# Knurled Steel Pull Rolls for In-line Bander Upgrade

13-0101 (0914)

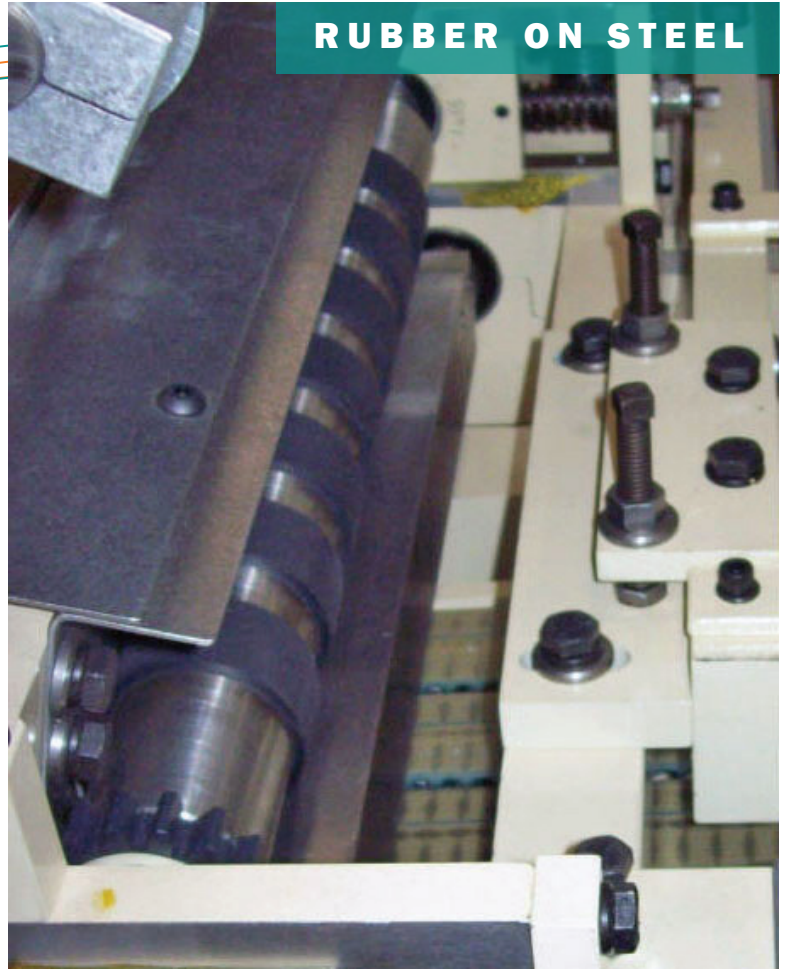
The previous In-Line Banders had a rubber roll against a steel pull roll. This offered good control of the sheet until the rubber roll began to wear. This upgrade features two opposing steel knurled pull rolls. A third knurled roll is then located just in front the pull rolls to offer additional sheet control.

RUBBER ON STEEL

KNURLED STEEL ON STEEL

The advantage of this upgrade is precise sleeve control and more consistent sleeve length and longer life. This upgrade can be ordered as a complete package or you can simply order knurled rolls to replace the existing rubber and steel rolls currently in your machine.
